Technical Service Bulletin: TSB110104

Released Date: 11-Apr-2011

Cylinder Block Service Kits

Thin-Wall Cylinder Block

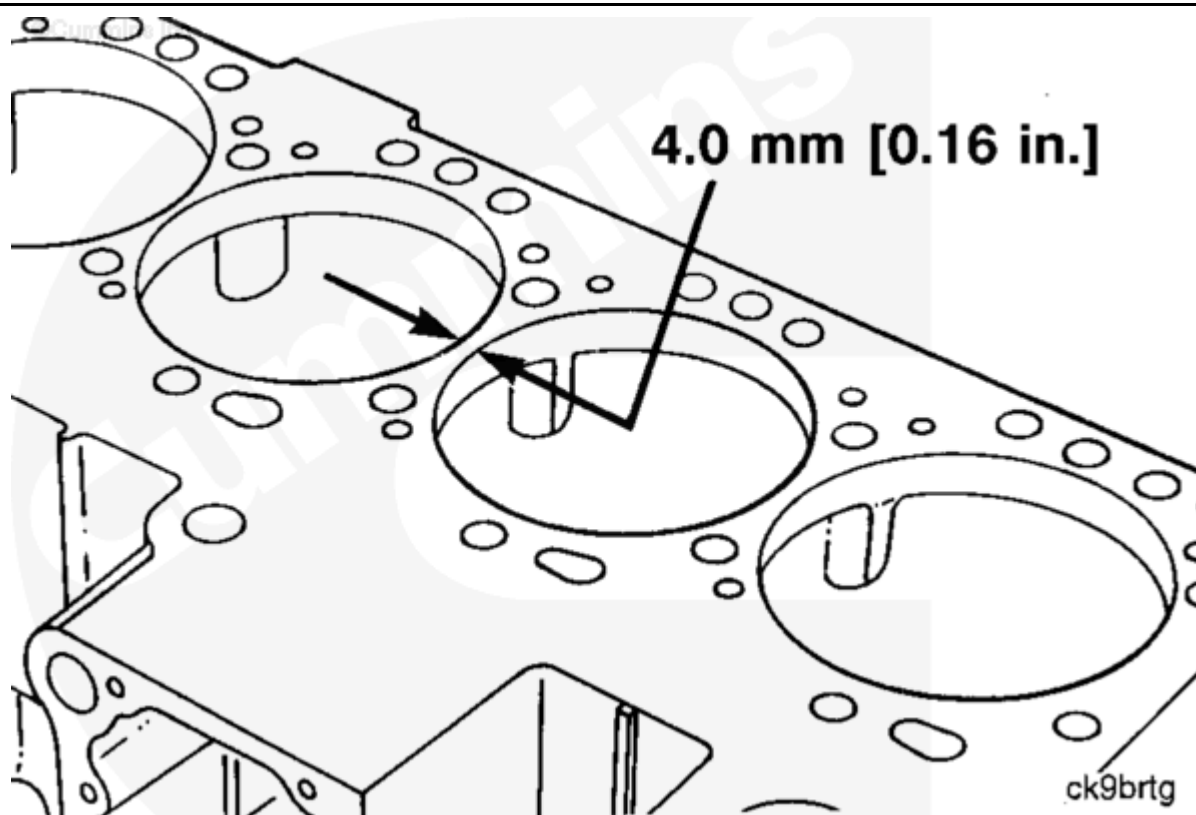
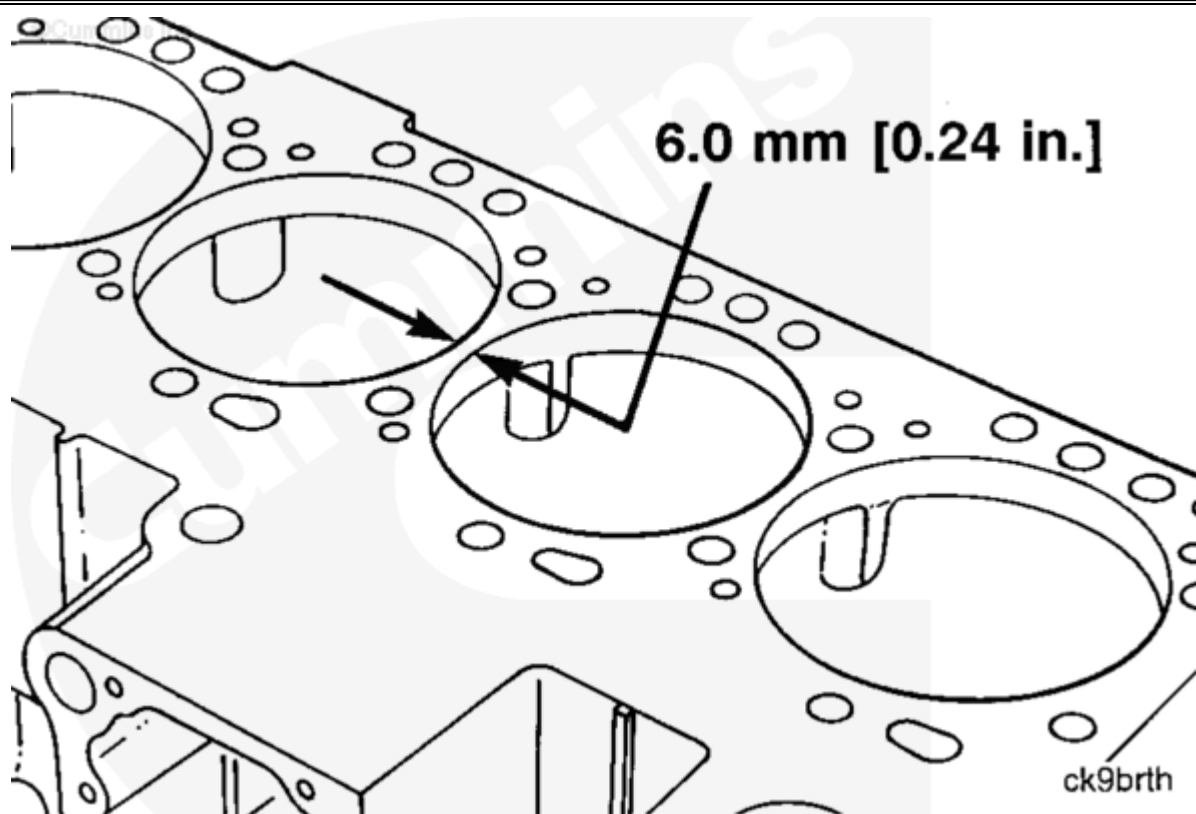
This document identifies the correct service cylinder bloc kits required to replace a C series cylinder block. The cylinder block used in **pre-1991** engines, **part number 3802265**, has been obsoleted and replaced by a cylinder block with thick walled cylinder liner bores, **part number 3802549**. Use the **part number 3802559** cylinder block as a replacement for engines produced during **1991** and after.

Pre-1991 engines were built with single piston cooling nozzles per cylinder and a lower capacity lubrication system. The cylinder block now in production has dual piston cooling nozzles per cylinder and a higher capacity lubrication system. This difference requires the use of the cylinder liner kit and service cylinder block kit listed below when replacing the cylinder block on engines built prior to **engine serial number (ESN) 44487830 (CDC), ESN 21083000 (DEP), and ESN 30417102 (BZL)**.

Engines with the following ESN's were built with dual piston cooling nozzles per cylinder, high capacity lubrication system and thin-wall cylinder block.

Use the following cylinder block kit when replacing the cylinder block. The cylinder liners **can** be reused **if** they meet the reuse guidelines.

Piston/Cylinder Kits For Use With Thick-Wall Cylinder Block, Part Number 3802549 and 3802559
